Form 3160-5
(June 2019)UNITED STATES
DEPARTMENT OF THE INTERIOR
BUREAU OF LAND MANAGEMENTFORM APPROVED
OMB No. 1004-0137
Expires: October 31, 2021**SUNDRY NOTICES AND REPORTS ON WELLS**
Do not use this form for proposals to drill or to re-enter an abandoned well. Use Form 3160-3 (APD) for such proposals.5. Lease Serial No.
NMSF078773
6. If Indian, Allottee or Tribe Name**SUBMIT IN TRIPLICATE - Other instructions on page 2**

LOGOS Operating request a change in plans for the following: g:

Well Name: ROSA UNIT	Well Location: T31N / R5W / SEC 33 / NENW / 36.862483 / -107.370925	County or Parish/State: RIO ARRIBA / NM
Well Number: 740H	Type of Well: CONVENTIONAL GAS WELL	Allottee or Tribe Name:
Lease Number: NMSF078773	Unit or CA Name: ROSA UNIT-MANCOS PA	Unit or CA Number: NMNM78407E
US Well Number: 300393136400X1	Well Status: Approved Application for Permit to Drill	Operator: LOGOS OPERATING LLC

Rosa Unit #740H

WELL LOCATION AND ACREAGE DEDICATION PLAT

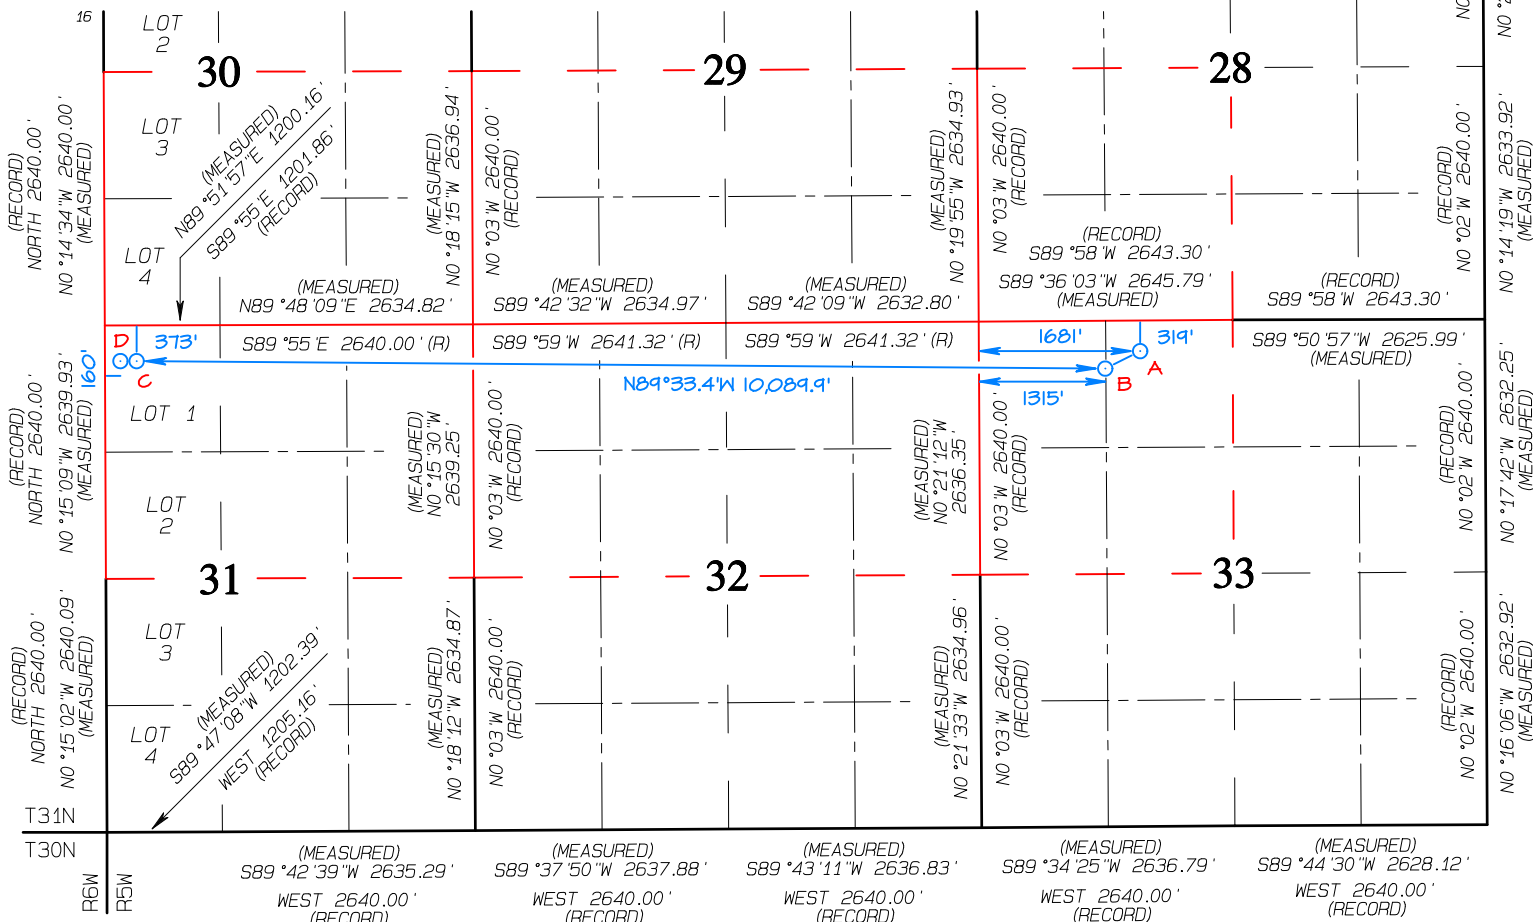
Original TD @ 17,927' MD 7,067' TVD to new **TD @ 17,737' MD 7,092' TVD.**

Attached: New C102, Operation and Directional Drill plans.

Plan: Plan #8 (Rosa Unit #740H/OH)

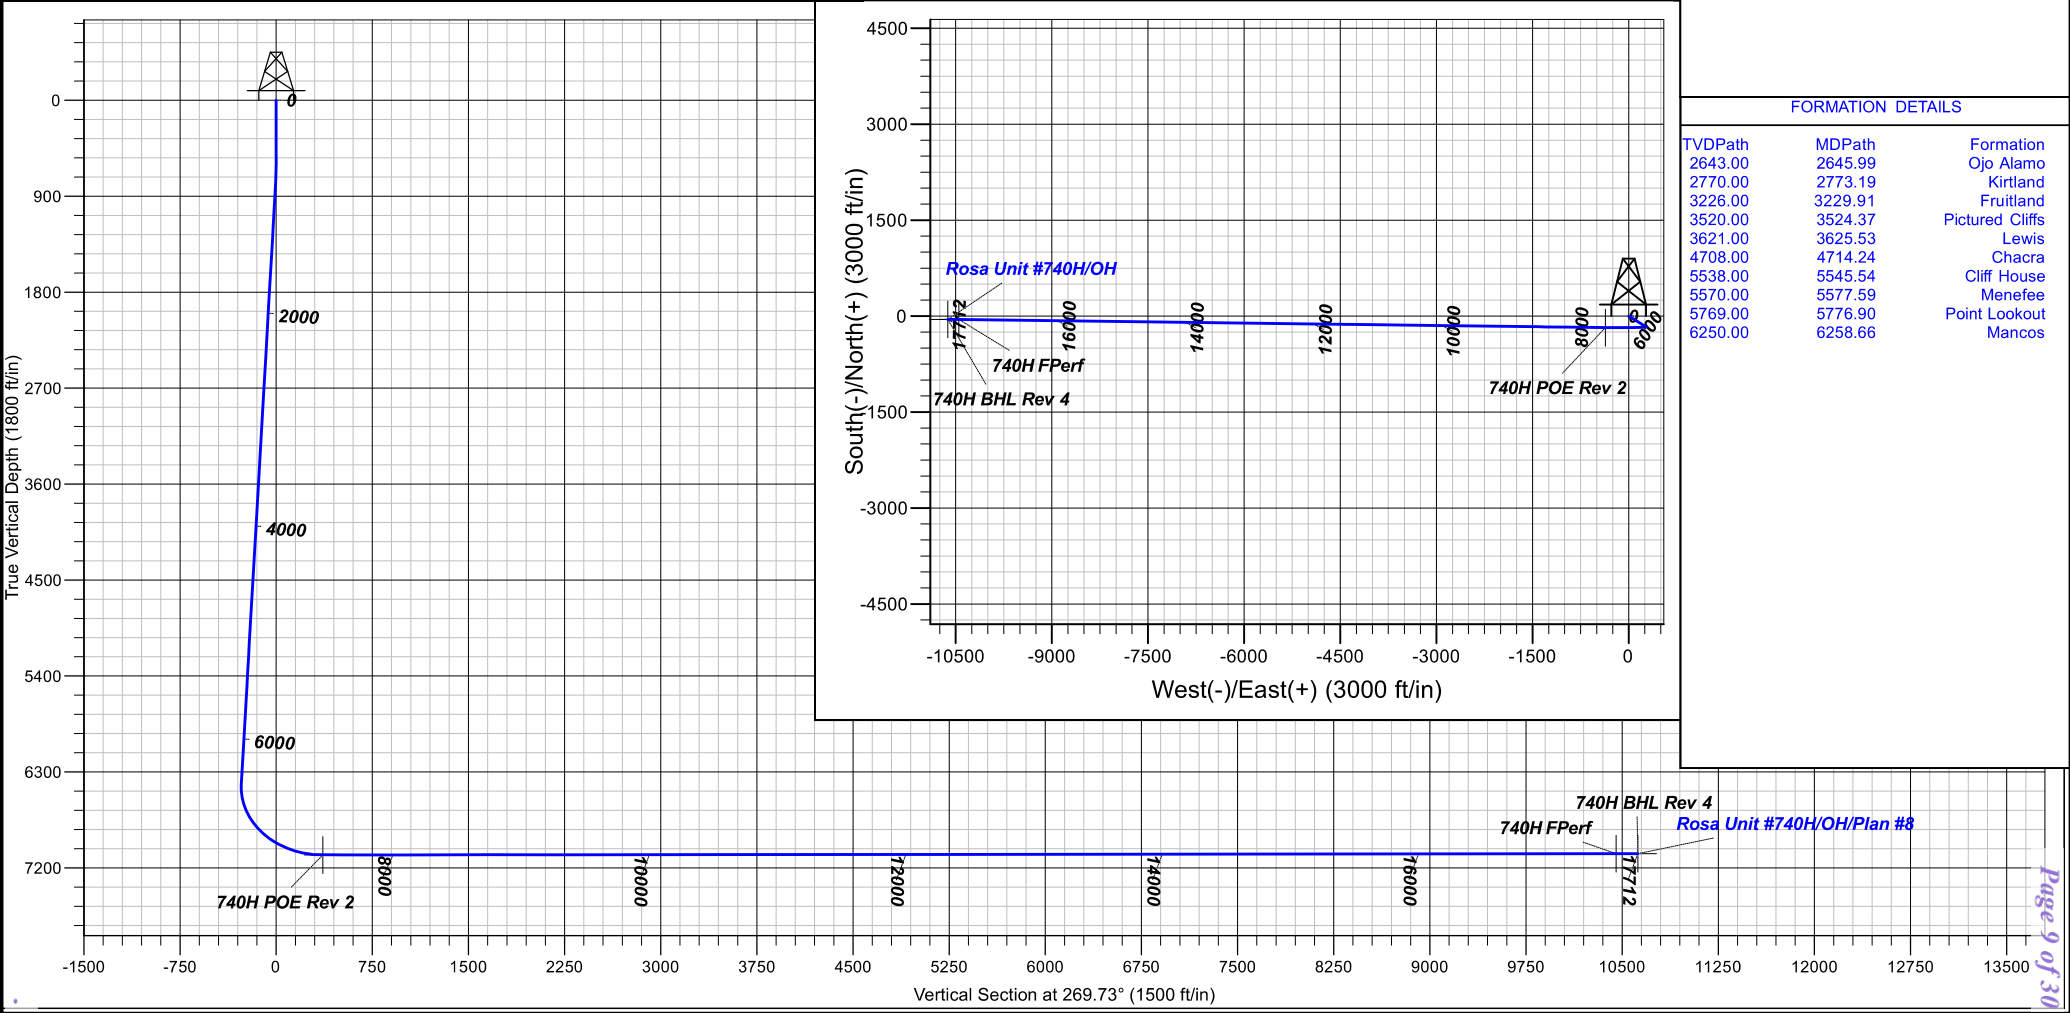
Original KOP @ 6,038' MD 5,997' TVD to new **KOP @ 6,421' MD 6,412' TVD**Original Landing point @ 7,667' MD 7,079' TVD to new **Landing point @ 7,477' MD 7,104' TVD**Original 9.625" casing Intermediate @ 6,367' MD to new **Intermediate casing @ 6,359' MD 6,350' TVD**Original 5.5" casing Production @ 17,927' MD to new **Production casing @ 17,737' MD 7,092' TVD**
